**ADDENDUM No. 1
SECTION 00 91 13**

**PROJECT: PROJECT OFFICE, STORAGE BUILDING
AND SITE IMPROVEMENTS IN WINONA,
MONTGOMERY COUNTY, MISSISSIPPI**

**PROJECT NUMBERS: BWO-2209-49(001) 502399
BWO-2208-49(001) 502399
LWO-2093-49(002) 502399**

DATE: APRIL 15, 2016

WORKING NUMBER: **E4.1**
 SHEET NUMBER: **50**

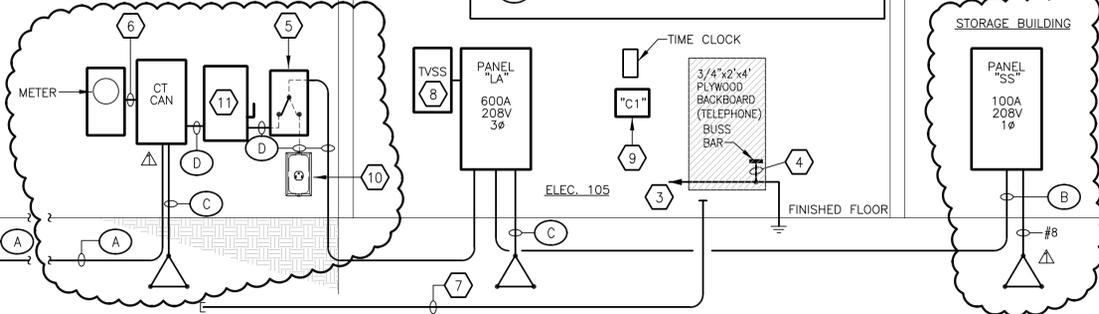
- G. The following revisions have been made to Working Number E4.1, Sheet Number 50:
1. Power Riser Diagram for Project Office – Revise riser diagram per attached revised Drawing E4.1.

2. Mechanical Equipment Electrical Schedule – Revise room numbers in location column per revised Drawing E4.1.
- H. The following revisions have been made to Working Number E4.2, Sheet Number 51:

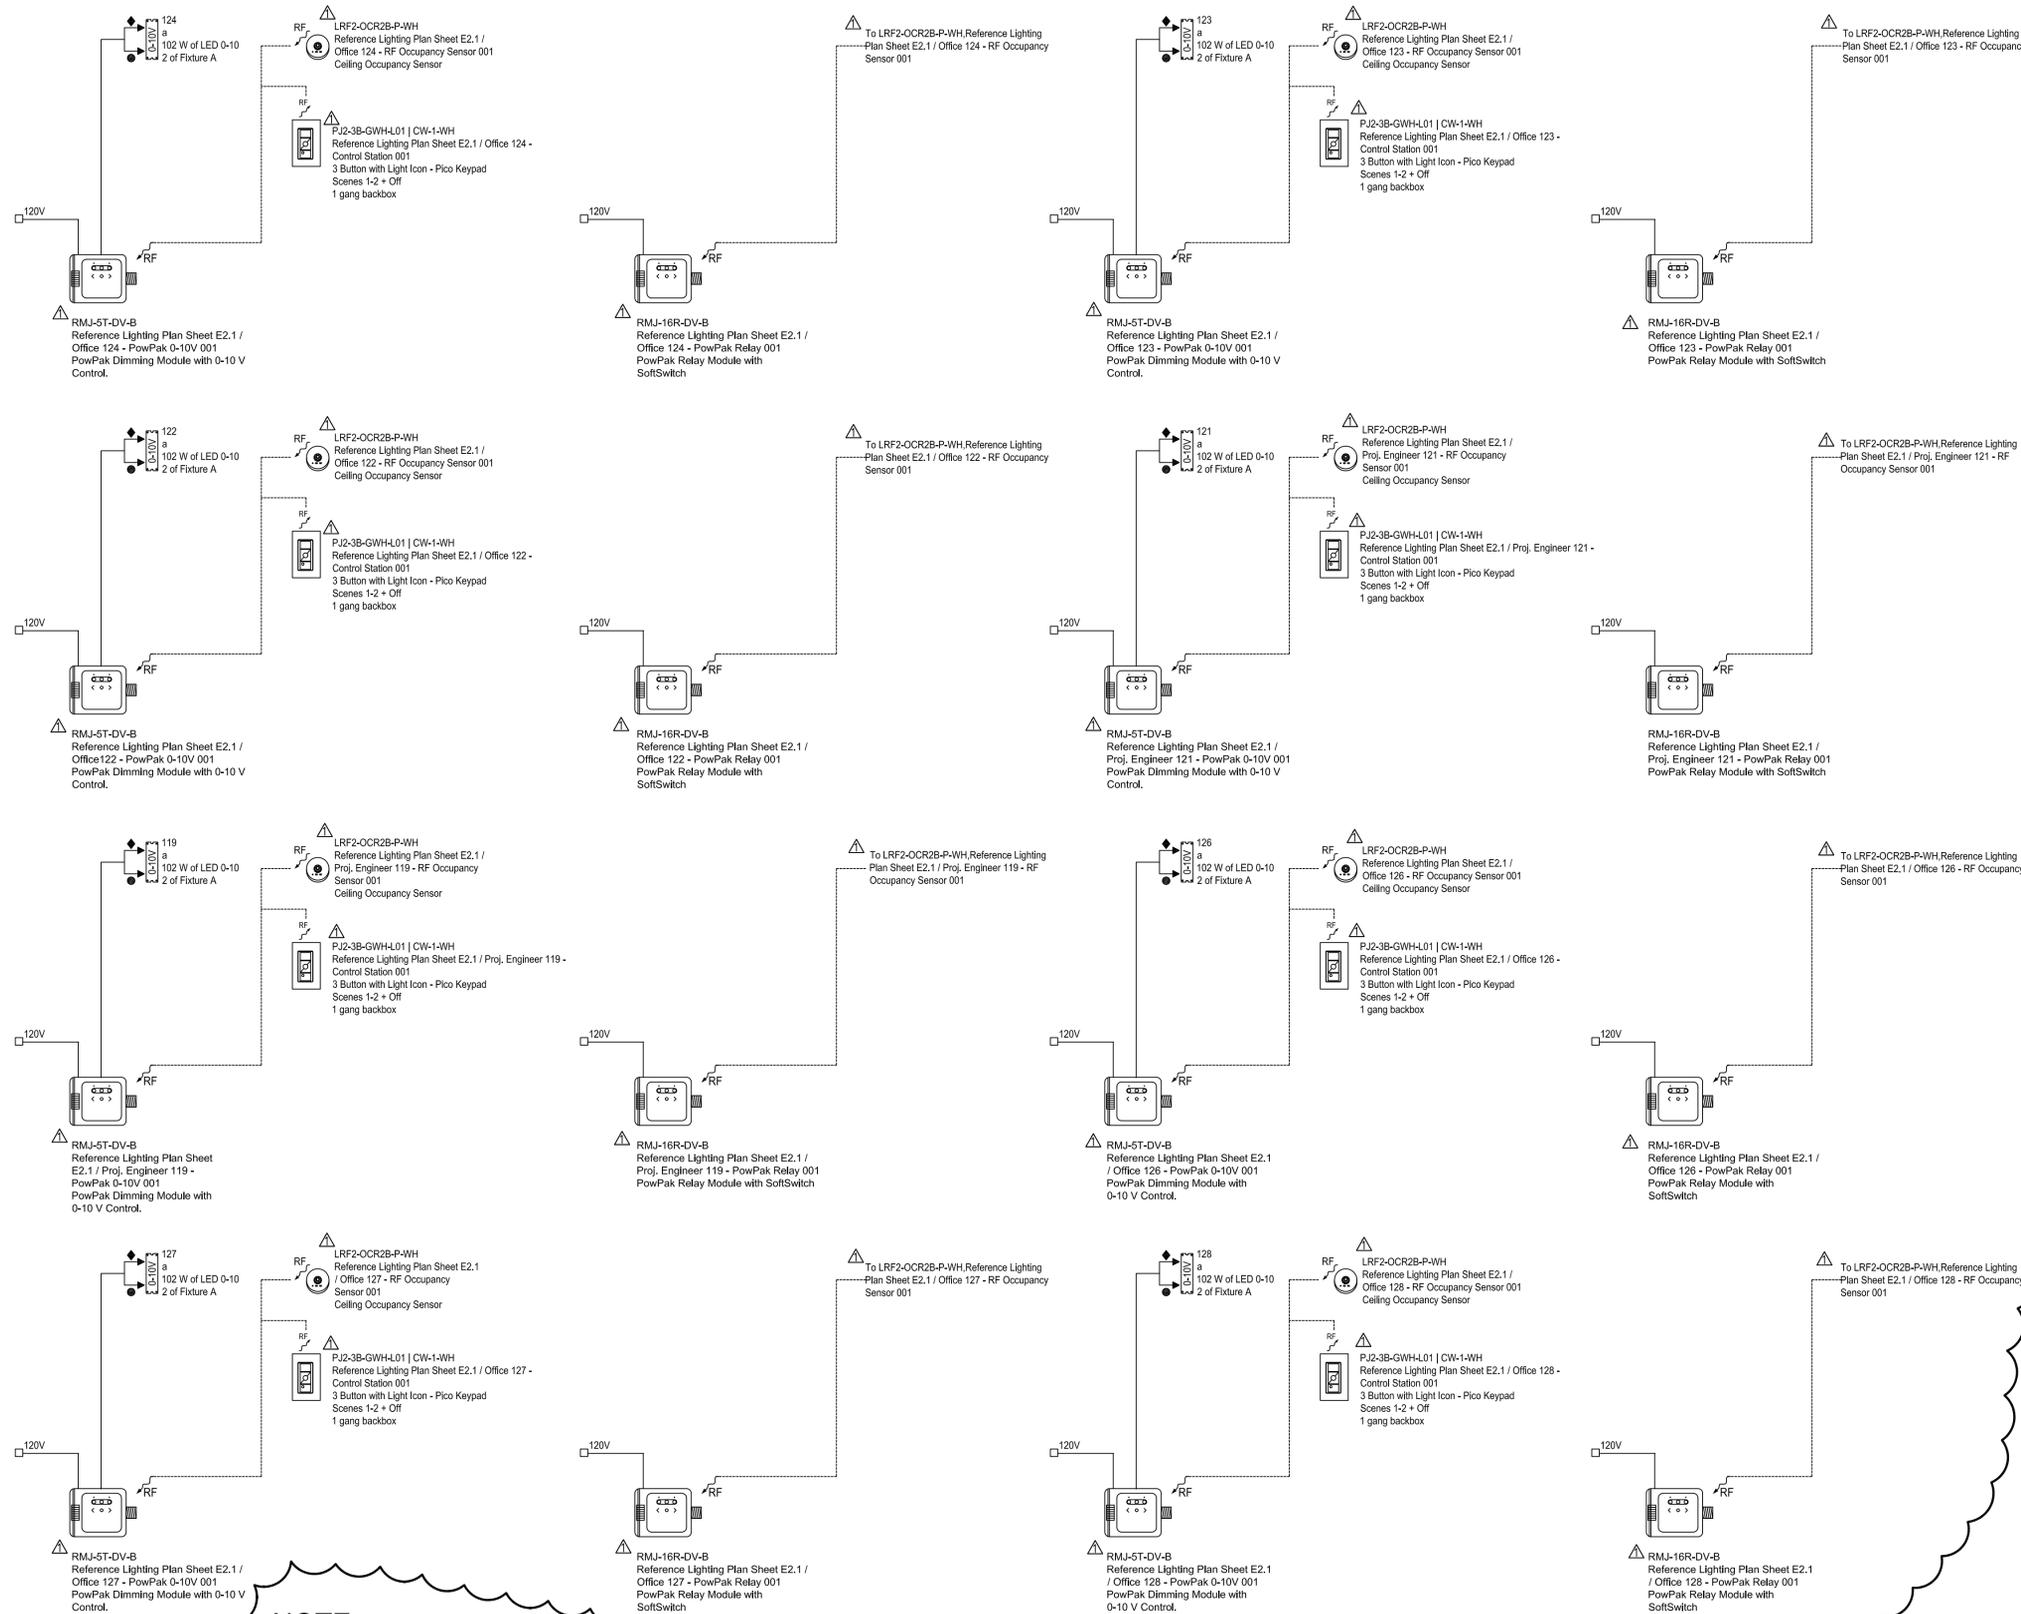
- J. The following revisions have been made to Working Numbers E5.2, Sheet Number 54; E5.3, Sheet 55; and E5.4, Sheet 56:
1. Electrical Low Voltage Riser Diagrams have been revised on these Drawings.
